Letter No. 306
BY-CRE-04303

Project: I-405/Brickyard to SR 527 – Improvement Project
Contract No.: 009727

Subject: Supplemental Notice of Protest 009 –SR522 Transit Hub Lighting

**Re: I-405/Brickyard to SR 527 Improvement Project (the "Project")
AECOM Project No. 60713342
Notice of Protest - Supplement Letter for Notice of Protest 009: SR-522 Transit Hub Lighting**

Exhibit 10 - Illumination Concept Plans

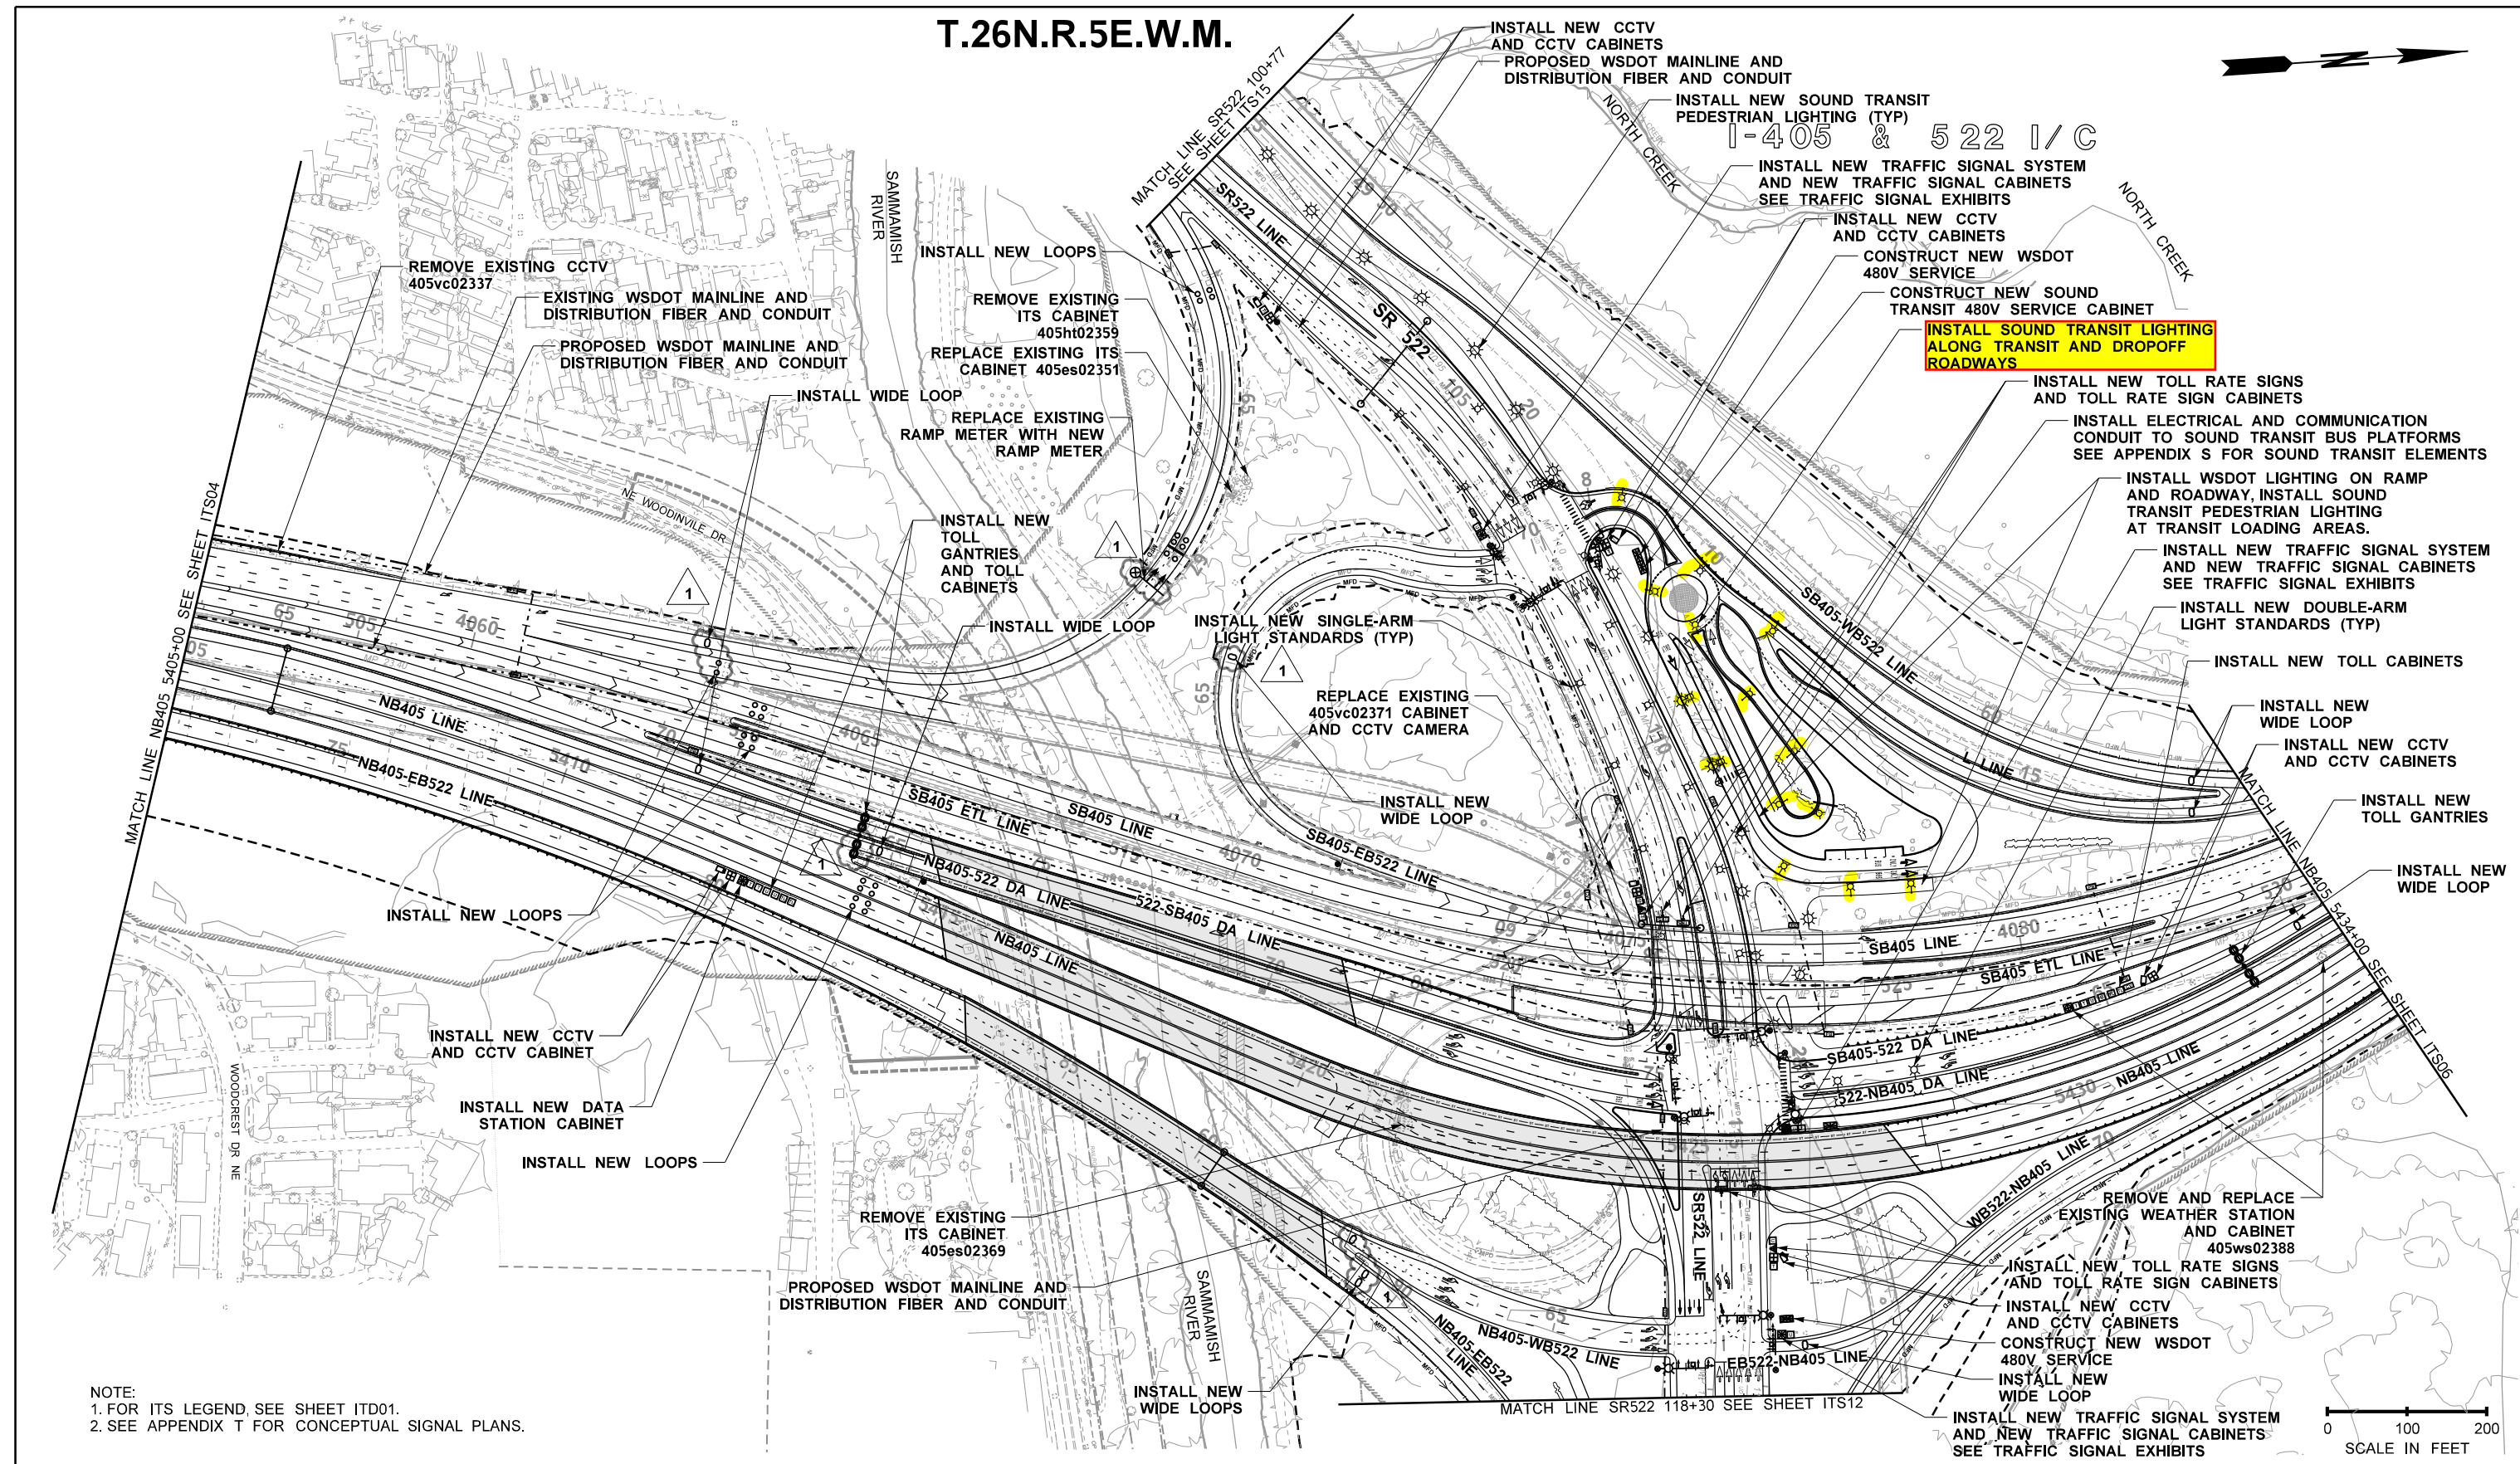
WSDOT Serial Letter 9727-199 is flawed in its statement regarding the 16' maximum mounting height limitation contained in the ST DCM. The RFP requires the design to be compliant with the ST DCM, which includes the required light levels for the bus roadway. The ST DCM also has a requirement for the pole light fixture mounting height to be between 12 and 16 feet, but as stated in the reference letter and discussed with WSDOT in traffic task force meetings #12 and #13, this is infeasible since the light mounting heights are too low to achieve the required lighting levels. In conclusion, the RFP is flawed or conflicted and the reason for the discussion with WSDOT in the first place. Where the ST DCM requirement for light pole fixture mounting height is applicable to stations and bus stops, it is not entirely applicable to roadway lighting. For a roadway bus hub such as the one called for on this project the light fixture mounting height needs to be more consistent with roadway lighting in order to achieve the required lighting levels. Further, this point is emphasized or confirmed by the lighting layout shown in the RFP Appendix M1-11 concept plans (Exhibit 10).
